JRPP No:	2010SYE056
DA No:	2010/113
PROPOSED DEVELOPMENT:	Demolition and new four (4) storey Residential Flat Building comprising 47 units, 61 car parking spaces in one (1) basement level + strata subdivison - 8-12 Marlborough Road, Homebush West
APPLICANT:	Tony Delutiis
REPORT BY:	Thomas Watt, Strathfield Council

Assessment Report and Recommendation

PROPERTY:	8-12 Marlborough Road, Homebush West
LOT & DP:	Lots 7, 8 and 9 in DP 827 Section 1
DA NO.:	2010/113
APPLICATION TYPE:	Residential flat building
REPORT BY:	Thomas Watt
REFERRED TO JRPP:	Yes (Capital Investment Value >\$10 million)
RECOMMENDATION:	Refusal
SUBMISSIONS:	No written submissions were received.
ZONING:	Residential 2(b)
DATE APPLICATION LODGED:	23 July 2010
APPLICANT:	Mr. Tony Delutiis Lulude Pty Ltd
OWNERS:	Mr. Tony Delutiis, Ms. Lidia Delutiis and Lulude Pty Ltd

Figure 3: Excerpt of map identifying areas of investigation under Part K of the SCDCP 2005.

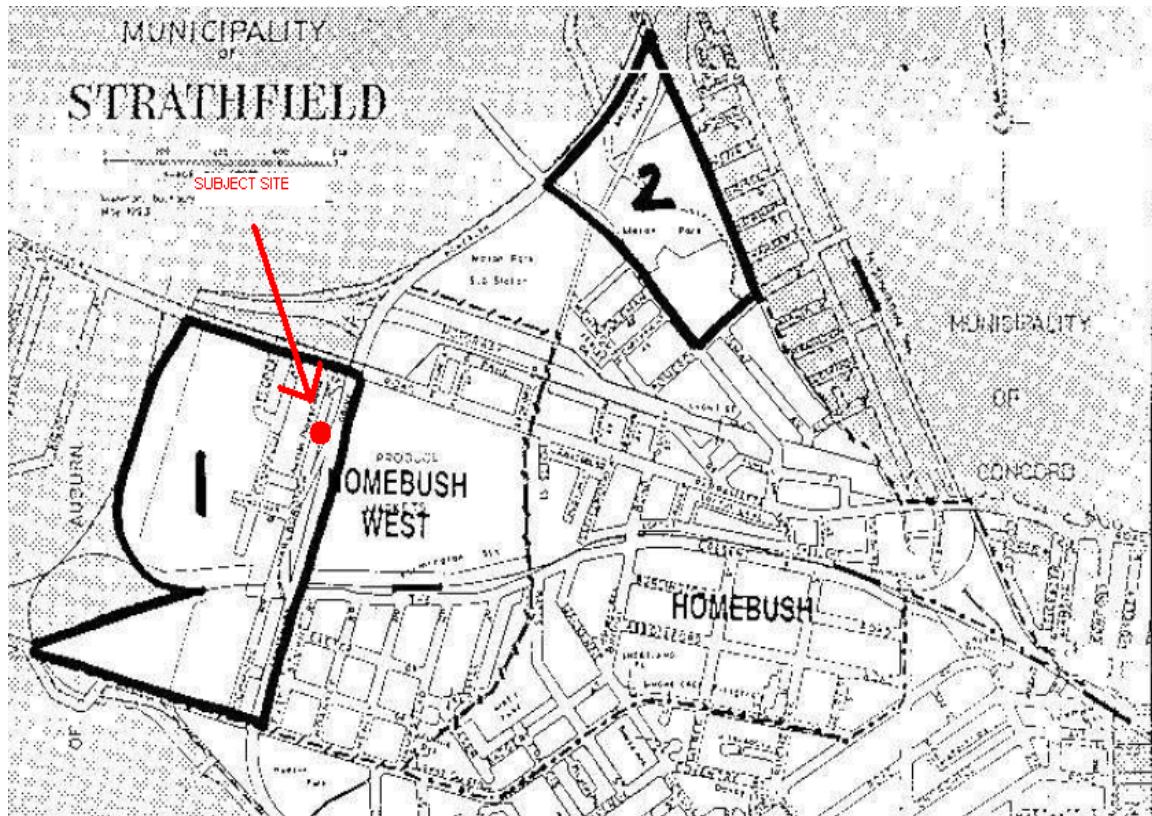
The site is located in an area of investigation identified in Figure 2 of Part K of the Strathfield Consolidated Development Control Plan 2005 (SCDCP 2005). A preliminary environmental site assessment carried out by Aargus Australia (September 2010) has been considered by Council in accordance with Clause 7 of SEPP 55.

Historical evidence suggests that shallow groundwater is potentially contaminated. The assessment undertaken by Aargus Australia is based on bore holes drilled to a depth of 0.7m at several locations across the subject site. This depth is insufficient to determine whether the land is suitable in its current state for the purpose for which development is proposed to be carried out, in particular, in relation to the excavation, construction and future use of the basement.

Accordingly, the proposed development has failed to satisfy the relevant provisions of State Environmental Planning Policy No. 55 – Remediation of Land.

Figure 10 – Parramatta Road Corridor Built Form Masterplan (cont)

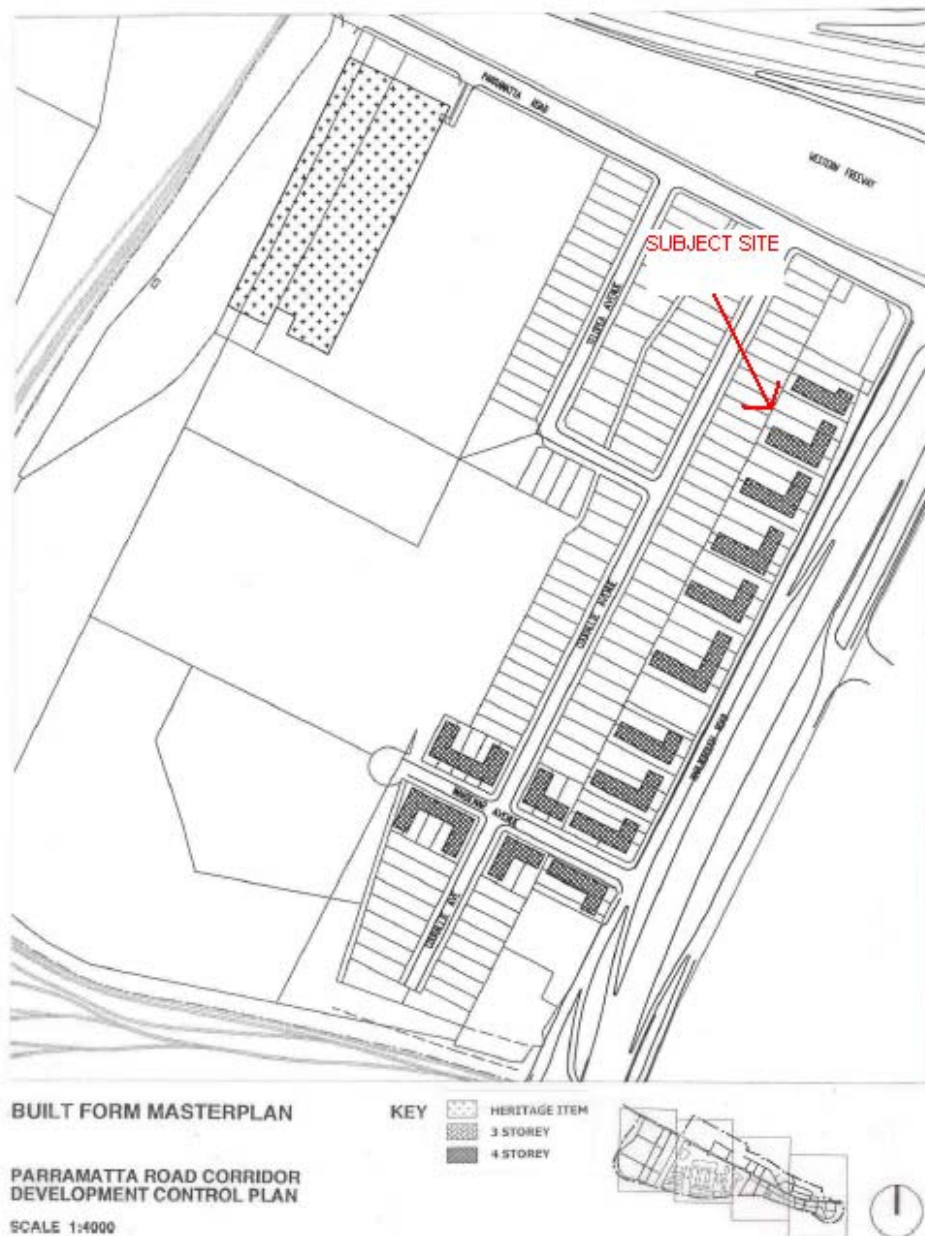
Section	Development Control	Required	Proposed	Compliance
2.2	Building Footprint	Proposal to conform to the building footprint shown in figure 10.	The proposed development exceeds the building footprint established in figure 10.	No
	Land Consolidation	Proposal to conform to the consolidation pattern identified in figure 13.	The proposal conforms to the consolidation pattern in figure 13.	Yes
	Basement Setbacks	The outer walls of basements shall comply with the setbacks required in this section.	Basement setbacks exceeds the building footprint exceeds that permitted in figure 10.	No

The proposed development is likely to adversely affect the context and setting of the site due to the building footprint non compliance. The proposed 'U' shaped footprint significantly exceeds the 'L' shape prescribed for the site under DCP No. 20. As a result, the proposed basement exceeds the setbacks for a compliant building footprint and reduces the availability of deep soil landscaping on the site.

- DCP No. 20 is based on a masterplan redevelopment strategy which encompasses objectives, standards and controls. Clause 1.3 of the DCP lists the objectives of the plan, which rely on the operation of the built form masterplan and building footprint. Accordingly, the intent of the building footprint control is governed by relevant objectives.

- Contrary to the applicant's assertion, DCP No. 20 has been consistently applied since its commencement date on 9 February 2000. The building footprint control, whilst varied slightly with respect to building width and basement setbacks, has consistently achieved an 'L' shape along Marlborough Road (with the exception of Nos. 34-36 and 38-40 in which the consolidation patterns were varied yet an 'L' shaped footprint imposed).
